STAFF REPORT Agenda Item #___

Project Title: 19 Jay Court Tree Permit Appeal

County File(s): CDTP24-00064

This is a hearing on an appeal of the Zoning Administrator's decision to tentatively approve a tree permit to allow the removal of three (3) code-protected oak trees in order to install a residential ground-mounted solar/photovoltaic (PV) system.

SHEET #
 PV-3.0

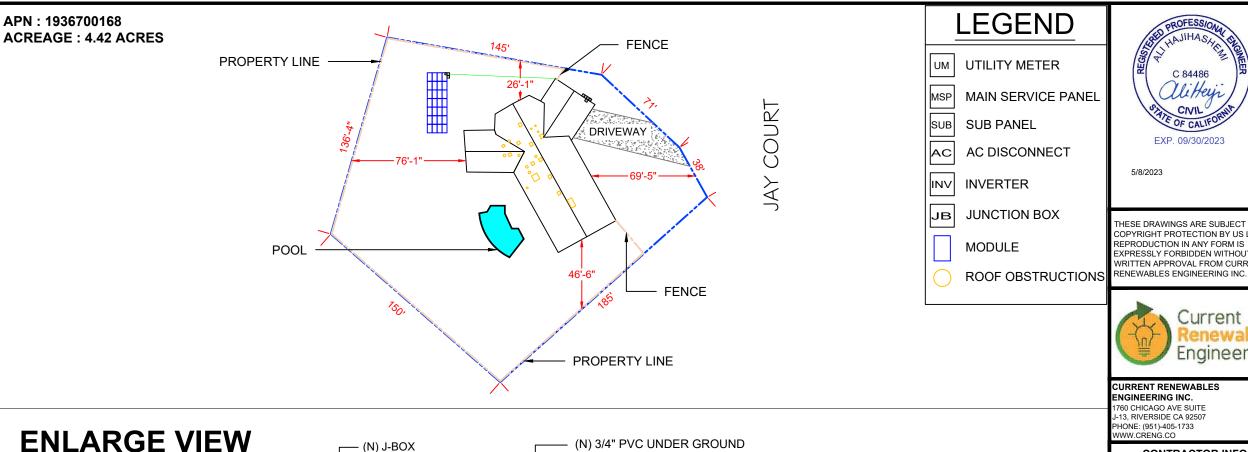
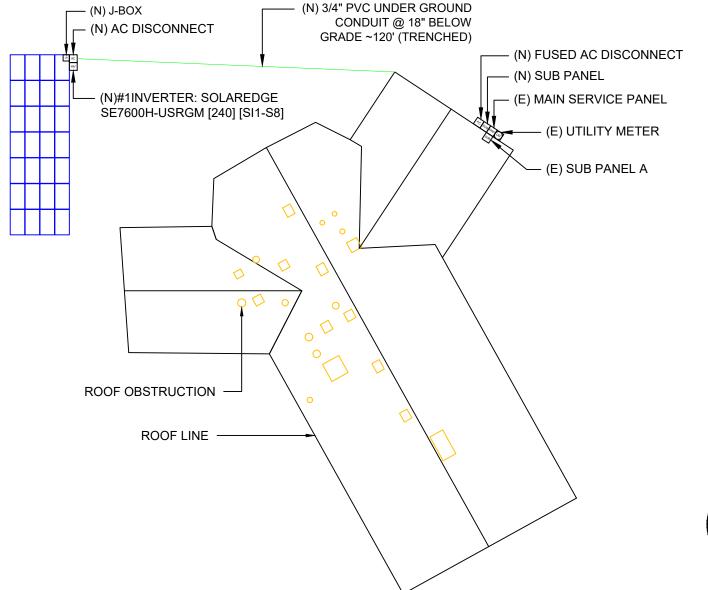
One other challenge on the Coastal Oak Tree: The Coast Oak is listed (Construction Plans, page2, The Mounting Plan) as having only a 12' spread, that is clearly wrong, more like twice that.

MOUNTING PLAN

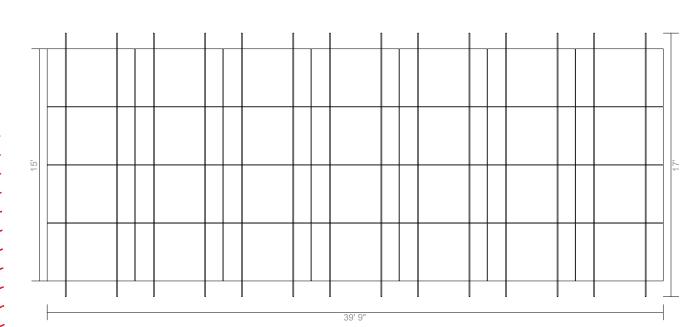
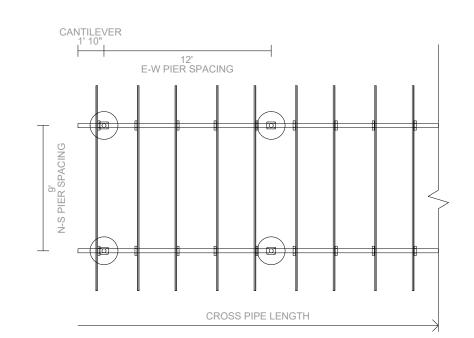
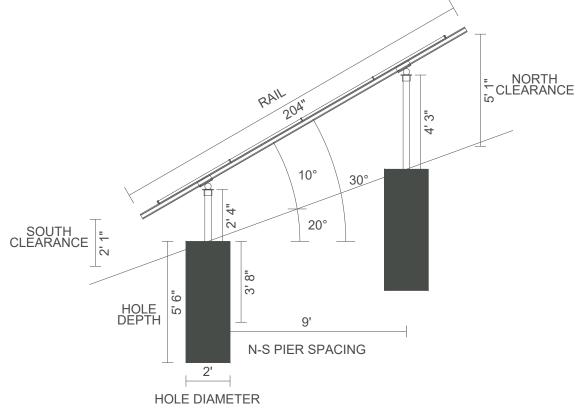
The pier depths must be at least 8 feet deep. The proposed plans call for pier depths ranging from 3'8" to 5'-6". That is too shallow. A more appropriate footing design would be 8 feet in depth.
